**Re: Sunset Apartment
SE Corner of Sunset Gardens Rd. & 86th St.
Traffic Circulation Layout
Engineer's Stamp 12-21-22 (L10-D032)**

The TCL submittal received 12-28-2022 is approved for Building Permit by Transportation. A copy of the stamped and signed plan will be needed for each of the building permit plans. Please keep the original to be used for certification of the site for final C.O. for Transportation.

SUNSET APARTMENTS
ALBUQUERQUE, NM
TRAFFIC CIRCULATION LAYOUT

TRAFFIC CIRCULATION LAYOUT APPROVED

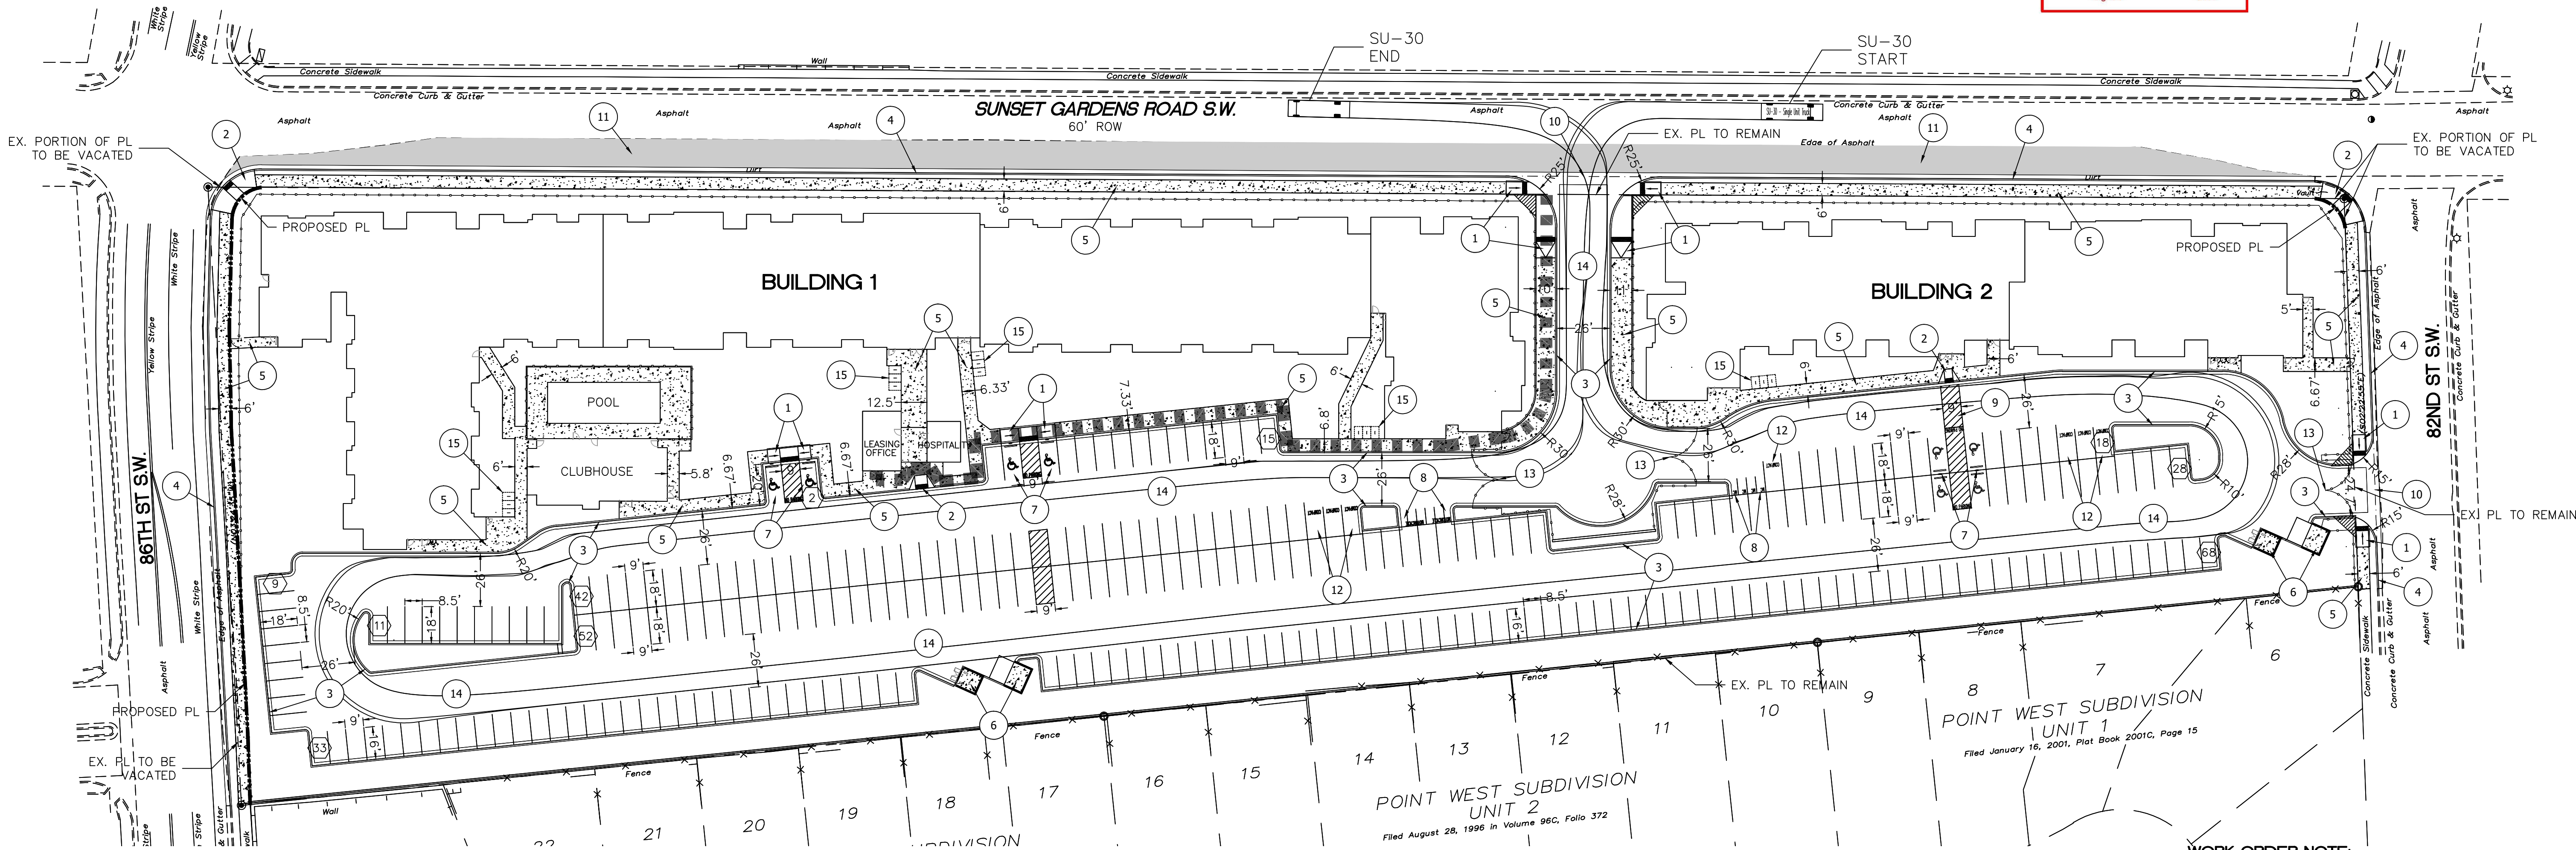
An Approved/Accepted work order must be provided prior of final CO approval
